Addendum 12H: Regulation No. 13-H

Revision 1 - Amendment 2

Supplement 7 to the original version of the Regulation: Date of entry into force: 22 July 2009

**UNIFORM PROVISIONS CONCERNING THE APPROVAL OF PASSENGER CARS
WITH REGARD TO BRAKING**

Annex 2, model "A" and the accompanying text, amend to read:

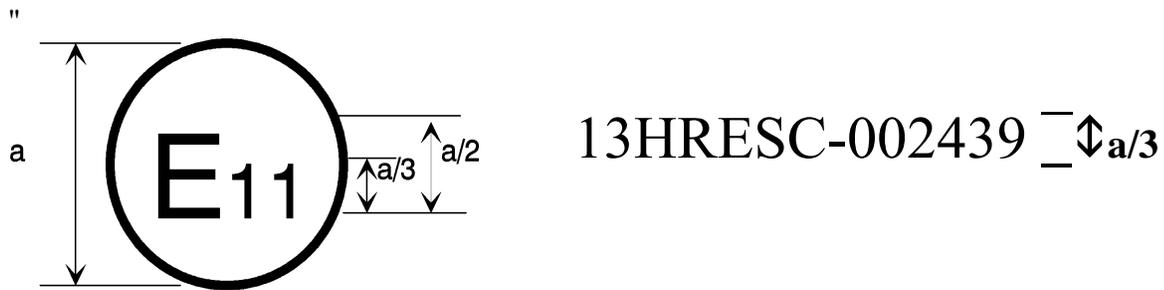
The above approval mark ... in its original form. The additional marking "ESC" indicates that the vehicle meets the Electronic Stability Control requirements of Annex 9 to this Regulation."

Figure 1. Steering wheel position and yaw velocity information used to assess lateral stability.

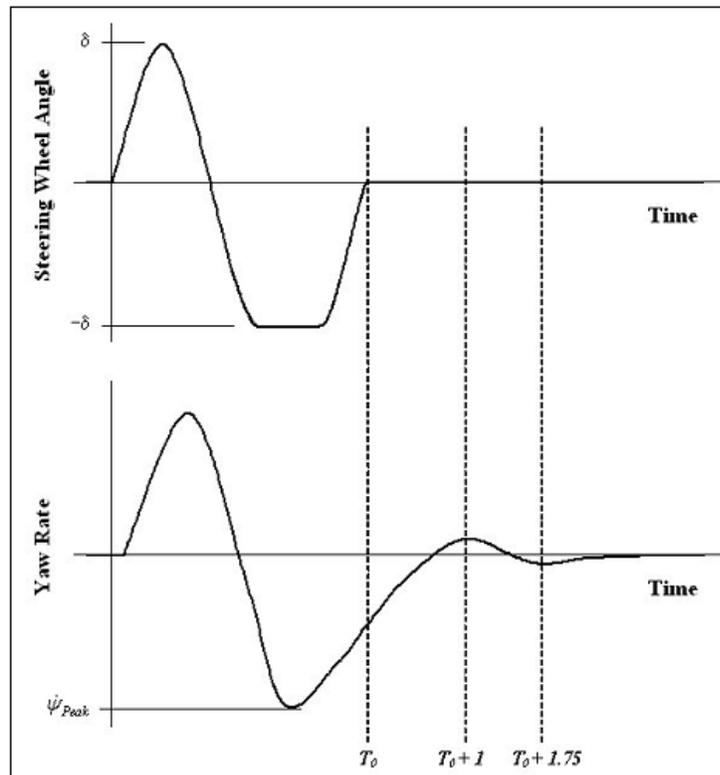
- 3.1. The yaw rate measured 1 second after completion of the Sine with Dwell steering input (time $T_0 + 1$ in Figure 1) shall not exceed 35 percent of the first peak value of yaw rate recorded after the steering wheel angle changes sign (between first and second peaks) ($\dot{\psi}_{Peak}$ in Figure 1) during the same test run.

3.2. The yaw rate measured 1.75 seconds after completion of the Sine with Dwell steering input shall not exceed 20 percent of the first peak value of yaw rate recorded after the steering wheel angle changes sign (between first and second peaks) during the same test run.

Figure 2 Sine with Dwell

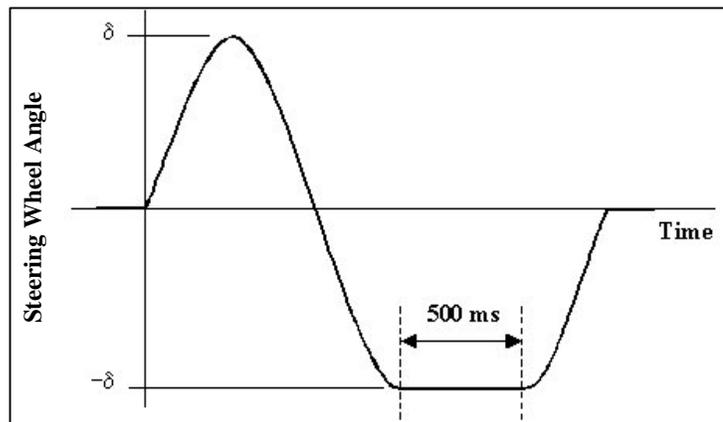
The vehicle is subjected to two series of test runs using a steering pattern of a sine wave at 0.7 Hz frequency with a 500 ms delay beginning at the second peak amplitude as shown in Figure 2 (the Sine with Dwell tests). One series uses anticlockwise steering for the first half cycle, and the other series uses clockwise steering for the first half cycle. The vehicle is allowed to cool-down between each test runs for a period of 1.5 to 5 minutes, with the vehicle stationary.

- 5.9.1. The steering motion is initiated with the vehicle coasting in high gear at 80 ± 2 km/h.
- 5.9.2. The steering amplitude for the initial run of each series is $1.5 A$, where A is the steering wheel angle determined in paragraph 5.6.1.

- 5.9.3. In each series of test runs, the steering amplitude is increased from run to run, by $0.5 A$, provided that no such run will result in a steering amplitude greater than that of the final run specified in paragraph 5.9.4.

- 5.9.4. The steering amplitude of the final run in each series is the greater of $6.5 A$ or 270 degrees, provided the calculated magnitude of $6.5 A$ is less than or equal to 300 degrees. If any $0.5 A$ increment, up to $6.5 A$, is greater than 300 degrees, the steering amplitude of the final run shall be 300 degrees.
